**Expert Report on the Sio Silica Proposed  
Vivian Silica Sand Project**

The Rural Municipality of Springfield, Manitoba

Christopher J. Neville, M.Sc., P.Eng.

January 12, 2023

**Figure 13. Well clusters activated during 2025**  
Adapted from AECOM (2021b; Figure 6-5)

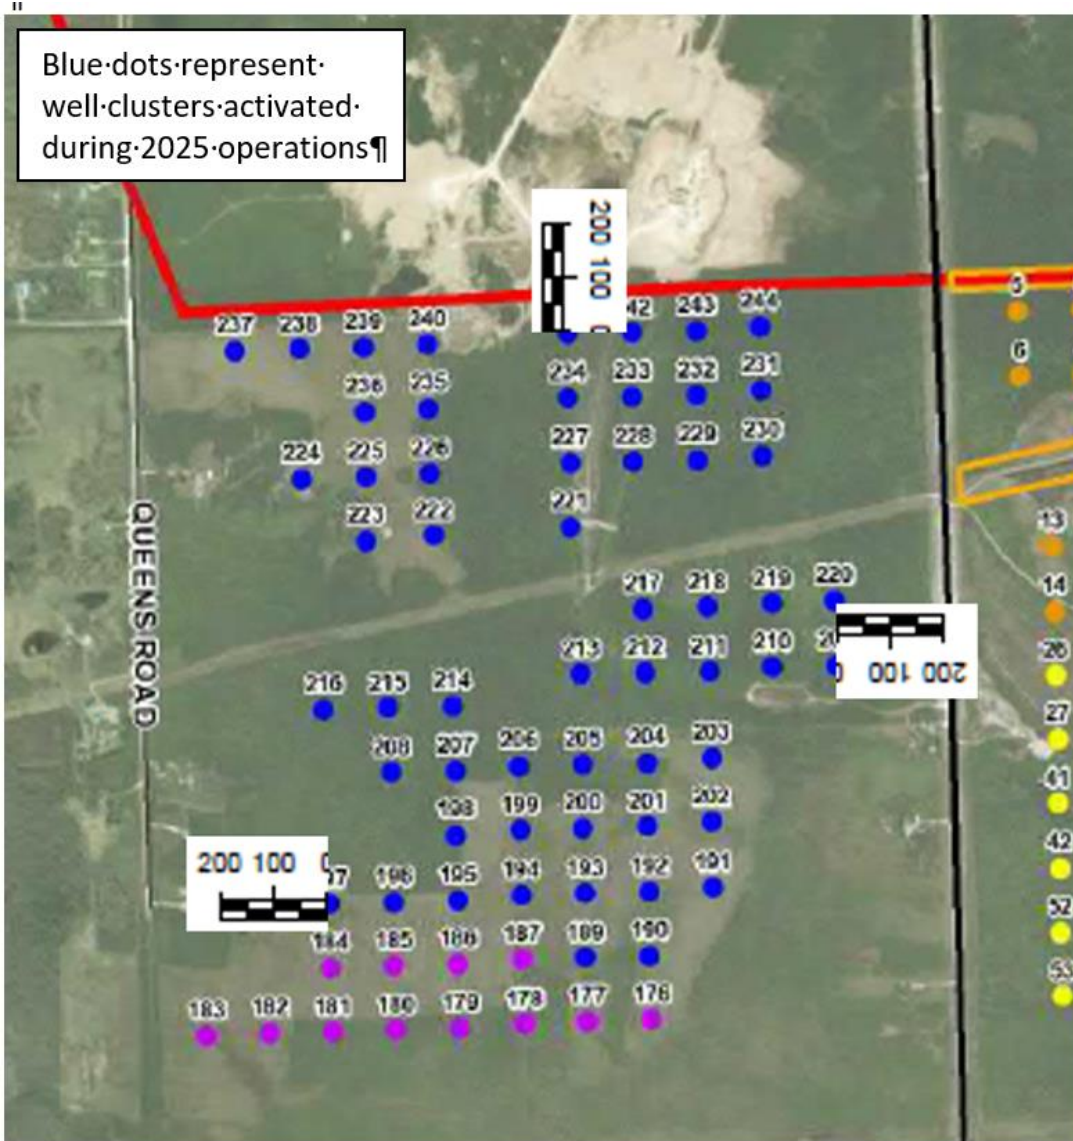
The assumption that between the voids created by mining the Winnipeg Sandstone aquifer will not be disturbed by mining and will remain intact is a very **strong** assumption. While there is no evidence that sand extraction will lead to widespread collapse of the Winnipeg Sandstone and the rock units that overlie it, there is no evidence that this possibility can be discounted outright. In the response to RMSF-IR-017 it is indicated that the scale of the project is regional. It is possible that the scale of the *impacts* of sandstone mining will also be regional in scale. In the response to RMSF-IR-005 reference is made to pilot testing. However, no descriptions of the pilot testing are presented and there are no indications as to whether displacements of rock unit were measured during the testing. Although it may not be possible to directly measure the magnitude of any change in aquifer properties prior to completion of mining, it is certainly possible to measure ground movements and changes in groundwater conditions around the site during operations.

In the response to RMSF-IR-018 it is indicated that the areas with the potential for degradation of the Winnipeg Shale are estimated to be 188 ha (Year 0) to 691 ha (Years 1 through 4), “based on the simplified assumptions taken during groundwater modelling”. These areas are sufficiently large to support detailed monitoring, which is the only real way to test the assumptions incorporated in the analyses. As the center of production shifts through time, the extent of zone of degraded shale is assumed to expand. Referring to the excerpt from Figure 6-5 of *Hydrogeology and Geochemistry Assessment Report*, shown here in Figure 13, the extent of the degraded shale is assumed to extend 200 m beyond the limits of the 2025 wells. It is indicated in the response to RMSF-IR-018 that the extent of the degraded zone will be “validated during operations”. This validation will be essential to demonstrate that the effects of mining are understood, controllable and limited to the Project Site Area.

**Figure 14. Results of simplified analysis of the transient response to pumping near well 30-10-8E1**

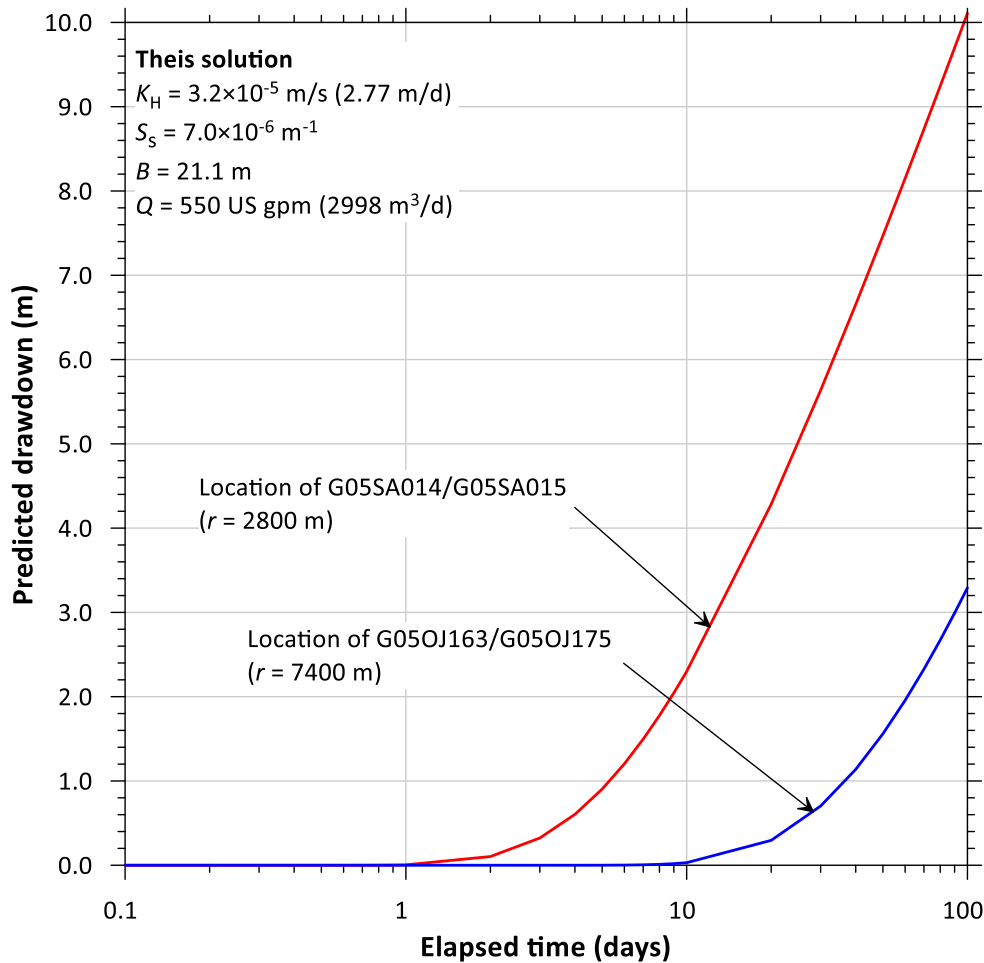
28. In theory, it should be feasible to conduct a back-of-the-envelope check on the results for the steady-state analysis of Scenario 3 (0% re-injection, no degradation of Winnipeg Shale). Referring to Table 6-1, steady-state drawdowns of 0.9 m and 0.0 are reported for G05SA014 and G05OJ163, respectively. The Theis (1935) solution is applied here with the parameter values listed on Table 6-C, assuming an aquifer thickness of 21.1 m and specifying the approximate radial distances between 30-10-8E1 and G05SA014 and G05OJ163. It is not clear why the results of the groundwater model are so much smaller than those estimated with the Theis solution. My expectation is that the steady-state analysis would provide conservative upper-bound estimates on the drawdown.
